## A. SEPA DNS

Pages 3-15: Issued 3-29-1979 (no mitigation)

## E. CUP03-003 – new FASPS and JCC expansion

## G. DSR03-022 – Final Design Review (FASPS)

FIGURE 10: LANDSCAPE PLAN  
21 JULY 2003

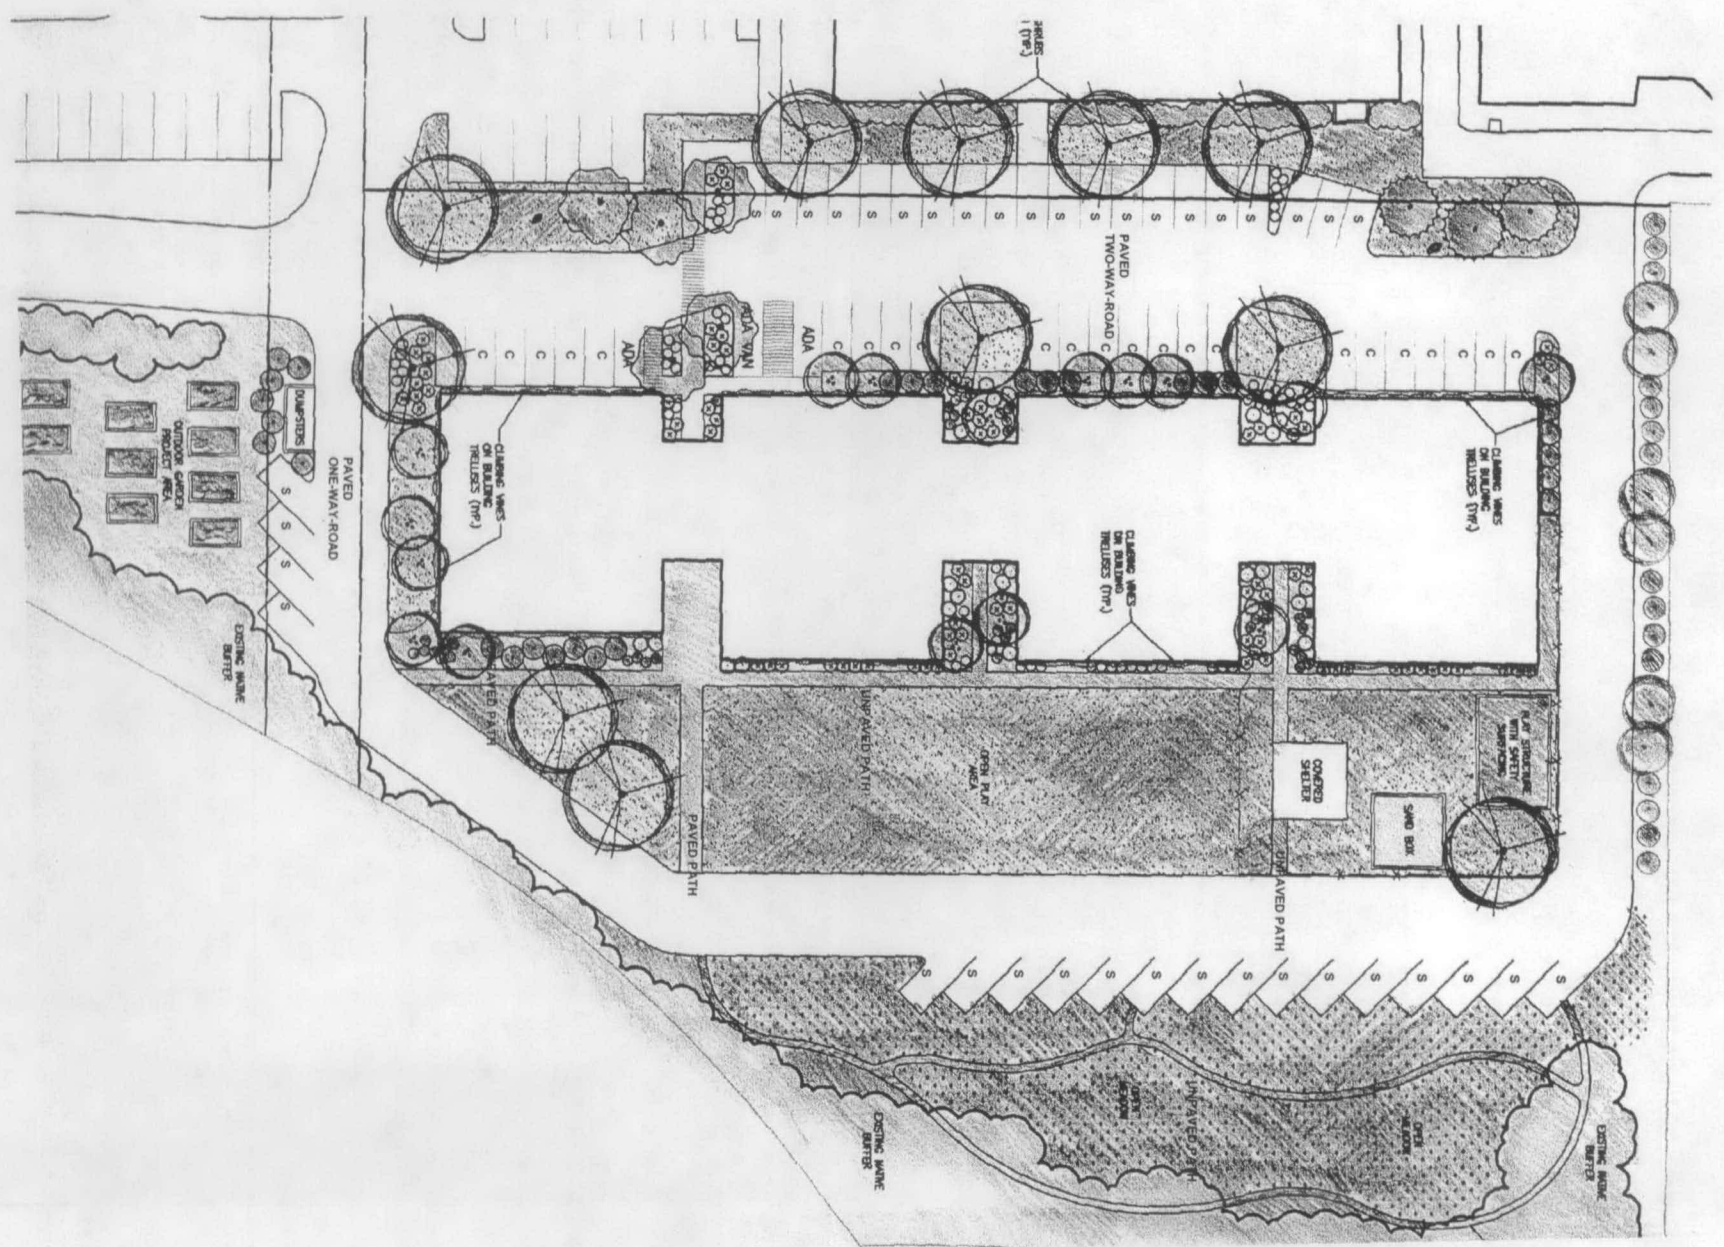
**The existing and proposed perimeter landscaping largely meets the partial screen requirement for lot boundaries abutting commercial uses. Staff recommends additional plantings be placed along the western property boundary abutting 9725 SE 36<sup>th</sup> Street, as the one tree for every 20 feet is not met in this area. (The Globe Building) See Sheets L-1.1 and L-1.2 – Landscape Plan**
